## **Bolt Positions on Base Plates**

*This problem occurs on many different types of projects and is a frustration to detailers and fabricators alike. The positioning of bolts on the centreline of base plates which clash with the bracings. It is caused by 2 dimensional thinking and not considering the bracing connections.*

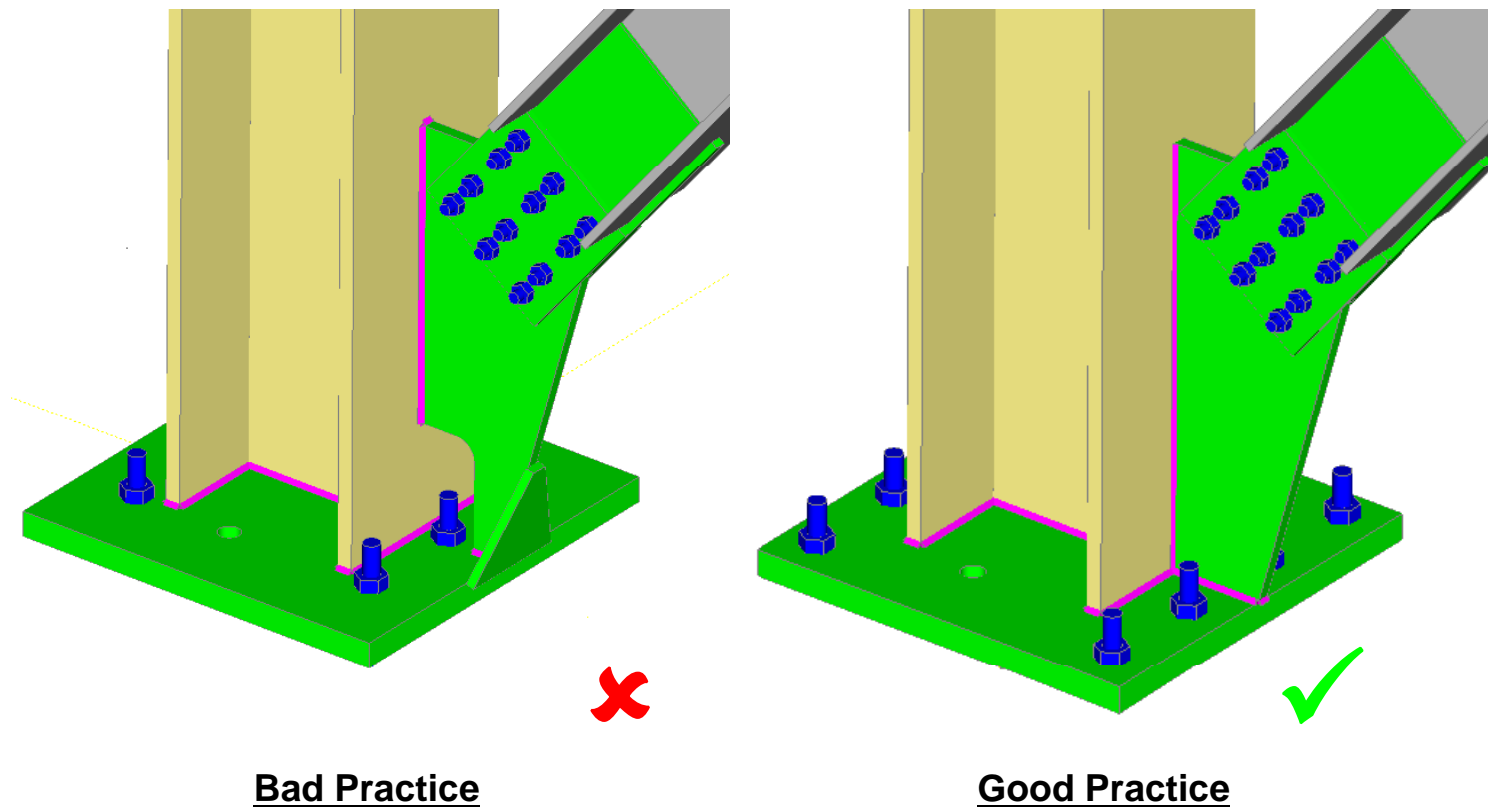
- The gusset plate requires notching around the holding down bolt meaning more fabrication and less effective weld area.
- Stiffening may be required at additional cost and looks unsightly.
- In some cases bolts are positioned too close to the column flanges can clash with the welds and restricts possible site modifications.

- Use 4 bolt base or 8 if necessary. Do not position bolts on the centreline of bases where a bracing is present.
- Take into account the distance from the flange to the centre of bolts allowing for the washers to fit without clashing with the welds. A good rule of thumb is 2 x bolt  $\varnothing$  minimum.
- Extra weld means a reduced weld stress and in turn a smaller weld size.
